Monthly Specification Update

Intel® Server Boards S5520HC, S5520HCT and S5500HCV

Intel Order Number E68105-012

December, 2010

27. Intel® Active System Console (IASC) 3.5.1 and 3.5.2 may fail to detect status of memory voltage sensors

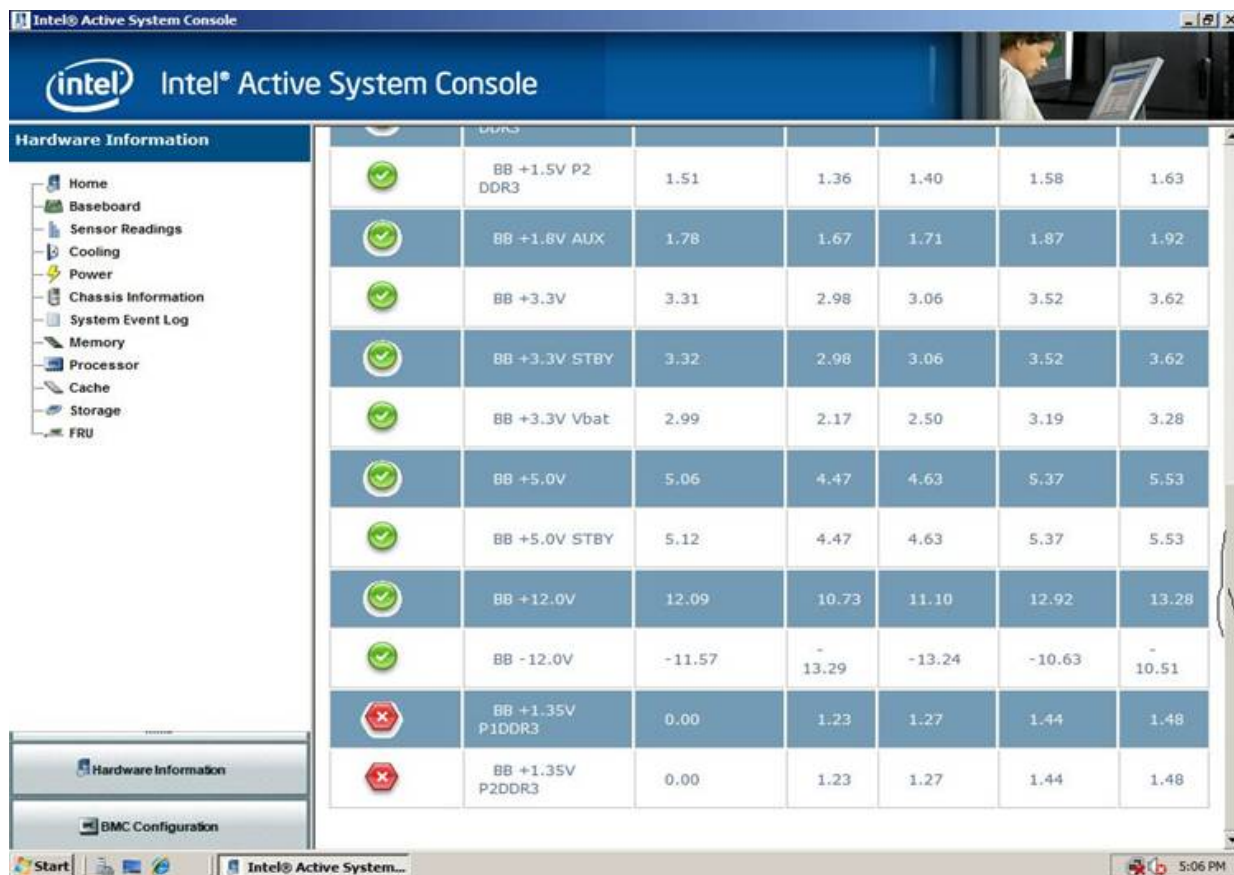
Problem	Intel® Active System Console (IASC) v3.5.1 and v3.5.2 is used to monitor hardware status on Intel server system. Intel® Xeon® 5500 Series Platforms start to support low voltage memory DIMM, so current FRUSDR has contained four memory voltage sensors "BB+1.5v P1DDR3", "BB+1.5v P2DDR3", "BB+1.35v P1DDR3" and "BB+1.35v P2DDR3", When system has 1.5v memory or 1.35v memory, only corresponding memory voltage sensors will be enabled, the other type memory voltage sensors will be disabled. IASC cannot judge the status of memory voltage sensors which have been disabled, and still try to detect those sensors reading. Because sensor reading is "0", lower than its threshold, so IASC shows those sensors status as critical warning. A screenshot of this failure is shown below:
---------	--

Implication IASC fails to judge the status of disabled sensors and still considers those sensors to server health algorithm.

Status This issue may be fixed in future IASC release.

Workaround None.
